Western Australian Speleological Group (Inc)

Report on a karst investigation of the site of the proposed Arrowsmith Hydrogen Project

Prepared for Infinite Green Energy
October 2022

Figure 2. WASG 1 October 2022 survey of average roof thickness above River Cave. © Brett Wiltshire

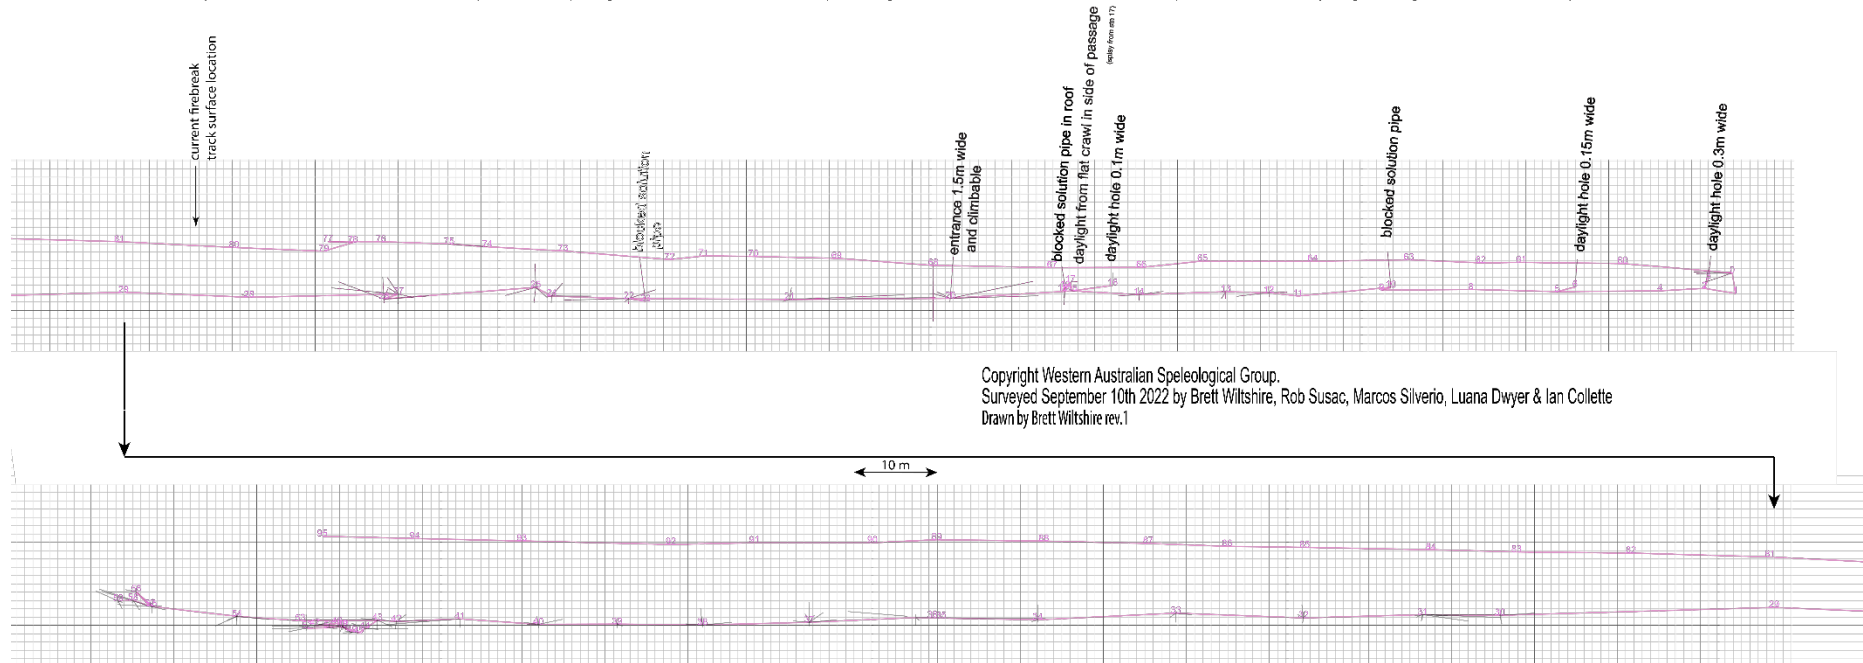
Current plans still show a road/track/powerline passing over the path of River Cave. WASG spent a large proportion of our time on the property measuring roof thicknesses and locating surface connections. The data is of interest for those interested in speleology but the simple conclusion for development purposes is that ideally nothing should pass over the cave for the sake of preservation. The cave roof thickens further away from the entrance and an existing firebreak track already passes over the cave a few metres from a surface connection.

The survey data (Figure 2) lower line is the underground line survey using any convenient point of the passage (floor, wall or roof). The upper line is the ground level recorded later following the same surveyed path on the surface. It should be noted that with cave surveying techniques every point is only as accurate as those that precede it and as such there is a cumulative uncertainty in the data. Also, due to natural hollows and projections in the cave roof, roof thickness measurement is a general approximation. In the daylight hole closest to the firebreak track, the cave ceiling thickness was recorded to be approximately 5.5m.

- 1 Review of final plans to confirm that any works in the River Cave catchment area will not cause sediment to flow into the cave in times of flood.
- 2 Review of final plans to confirm that the current track over the cave will be restricted to small vehicles only.
- 3 Review of final plans to confirm that any plans for infrastructure passing over the cave (even overhead powerlines) consider the expected unknown voids, the risks of erosion into the multiple small cave entrances due to earthworks, and the preservation of the unique geological values of the cave.
- 4 Trenching should not be carried out over the course of River Cave or in the vicinity of any of the known cave and karst features.

Figure 7. River Cave map overlaid onto aerial image. © WASG

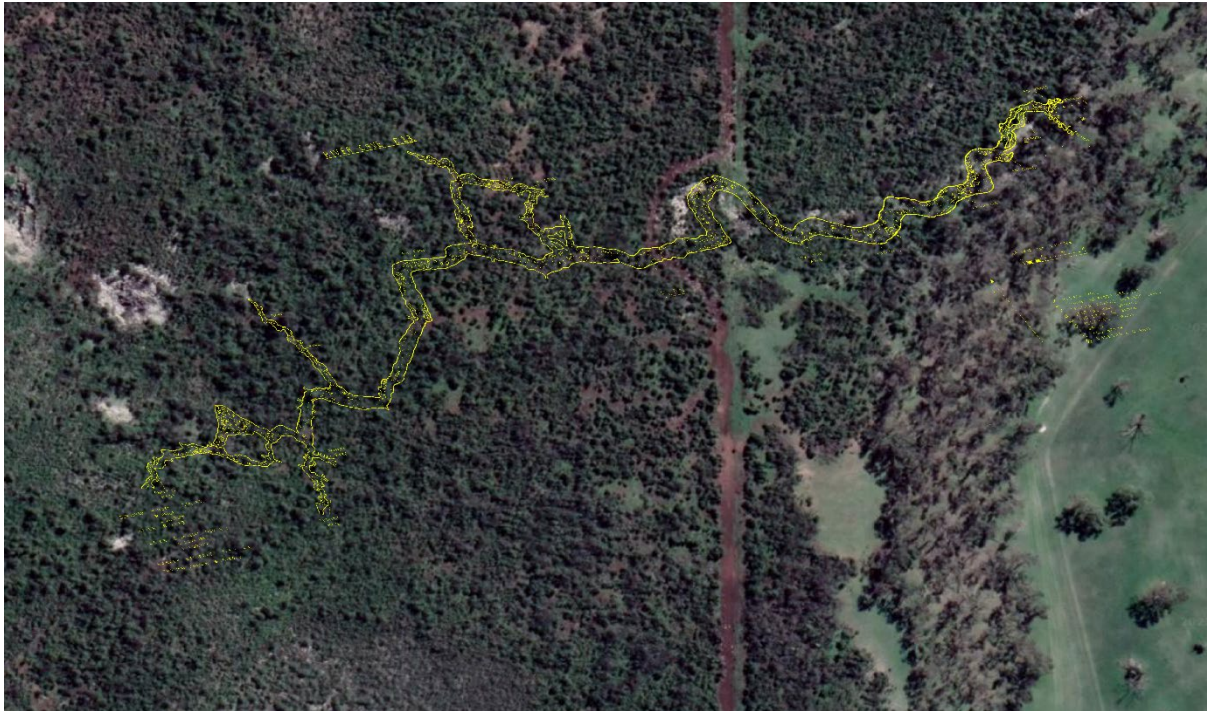
It is also of note that the firebreak track actually diverts around an area of the cave where a collapse/insoluble barrier has caused the cave passage to sharply divert. The firebreak track diverts around this but also then unfortunately follows directly above the cave passage for about 30m before crossing to the other side. (Some of this is visible in Figure 7, noting that the satellite imagery does not show recently created tracks.)

Multiple karst areas as described elsewhere. Figure 7 shows the line (track/firebreak) crossing the course of River Cave.

Cranes or heavy vehicles required for turbine construction should not be allowed to proceed along the tracks (old or new) north of WP11 as this area contains fragile voids. Any roads between known cave locations should be restricted to light vehicles only and no trenching of power cables should be permitted.

Figure 8. Arramall Cave map overlaid onto aerial image with other karst features also marked. © WASG

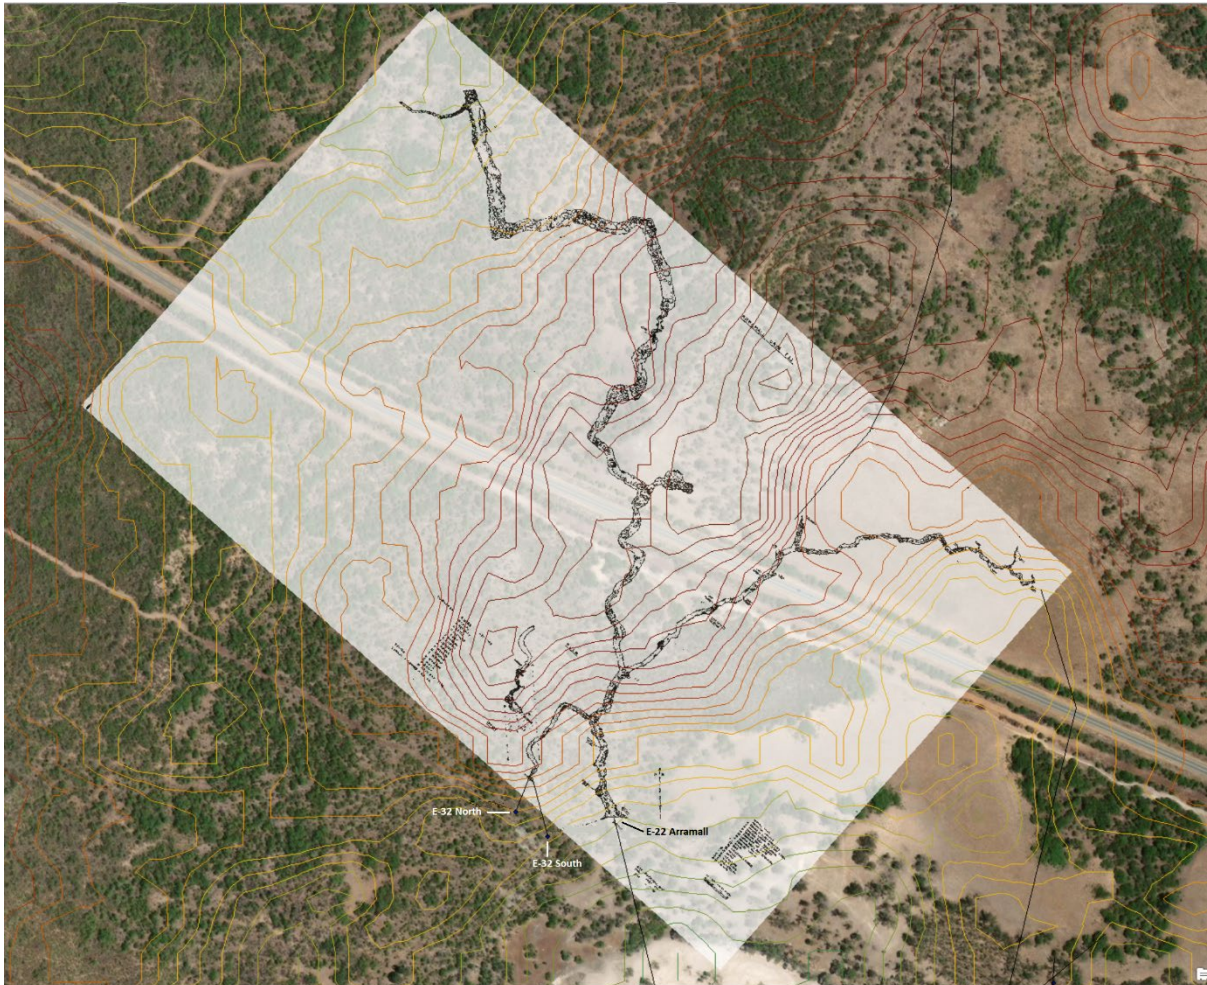
Arramall Cave is the longest known cave on private property in Western Australia. The cave passage splits and passes under Brand Highway in two locations and passes close to several known features on the neighbouring property (although no other entrances are known). There are also several other known caves and features near the entrance to Arramall, including E-48 Sponge Cave.

Current development plans show no development in this area and WASG recommends that this area is never developed.
